# CERTIFICATE OF APPROPRIATENESS PLACARD

Install gutters; install skylights

COA-0066-2020

CoA Minor Works Application  
Montfort Hall, 308 S. Boylan Ave Raleigh NC 27603  
Revisions to COA-0033-2019

Basement Floor Plan  
 10/18/12

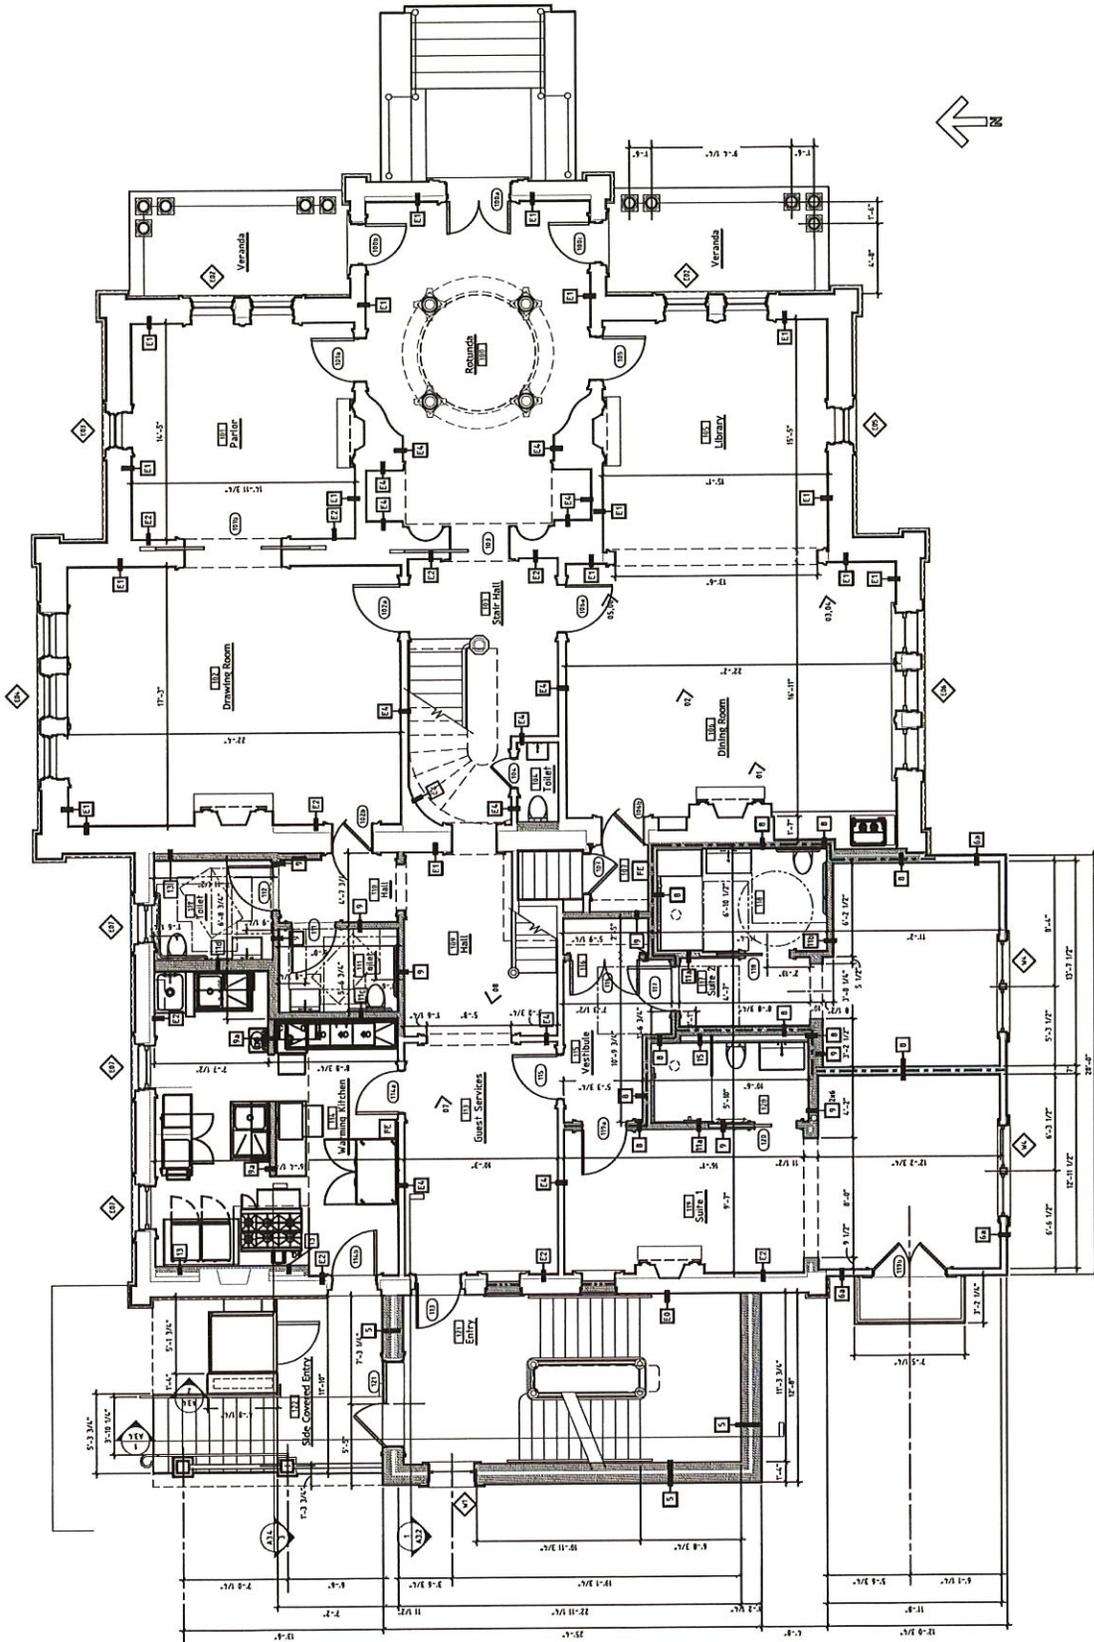
It may be my lack of at-home screen power, but I cannot figure out which basement door you're proposing to change. Can you help point me to the right place? Also, will the doors be custom or ordered? Do you have a spec? final thought – are they solid or will they have glazing?

the basement door really can't be seen from any elevation as it is under the rear porch entry, and I bubbled it on the attached basement plan. Both the basement door and the porch entry door are proposed to be double leaf half lite doors.

1 Roof Plan  
1/4" = 1'-0"  
11.02.22

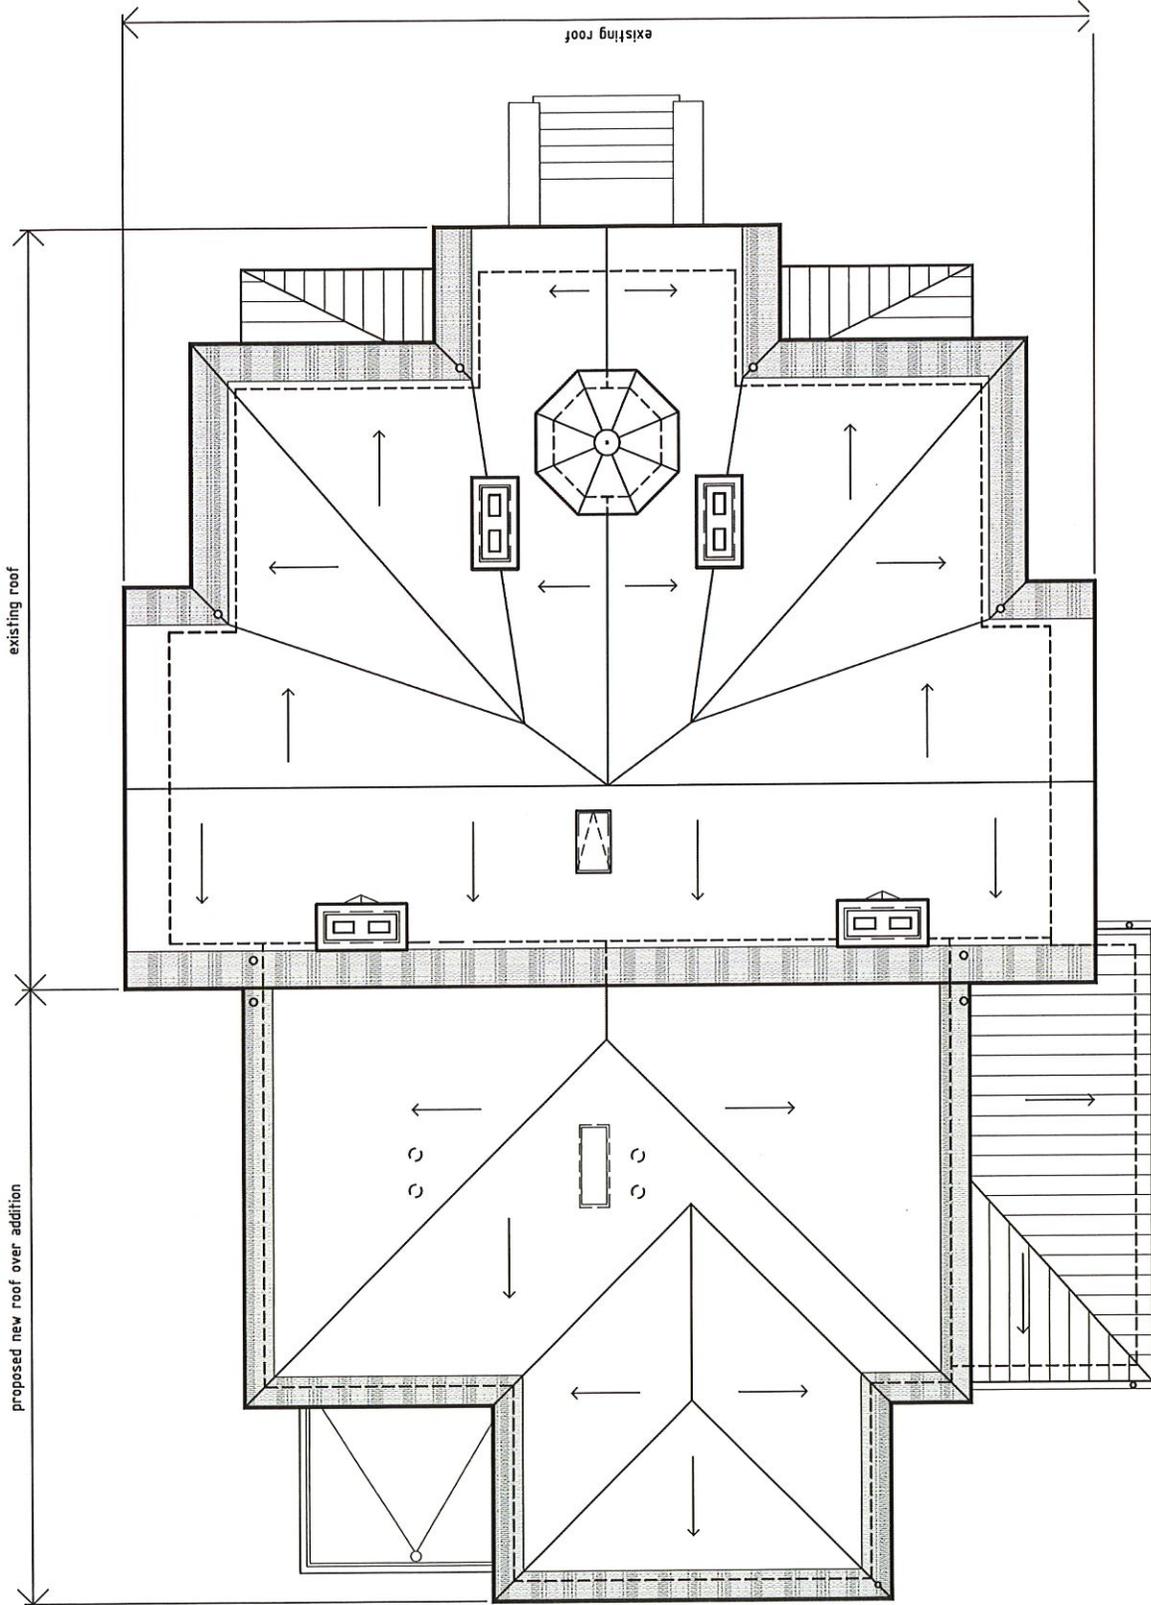
-New half-round copper gutters are proposed for the new addition roof (TPO membrane), the existing south addition roof (copper standing seam), the stair tower roof (TPO membrane) and the porch roof (copper standing seam) at new entry at rear of building. See roof plan for locations of downspouts.

-Small tube skylights are being proposed for the second floor addition roof. The daylighting system (Solatube 160 DS, specification attached) would not be visible from the exterior of the building. See the roof plan for solatube locations.

I didn't see any concern with the gutters or skylights, though could you show the gutter locations on the roof plan?

Attached are the updated elevations of the north and west facades. The gutters are shown on the roof plan, attached.
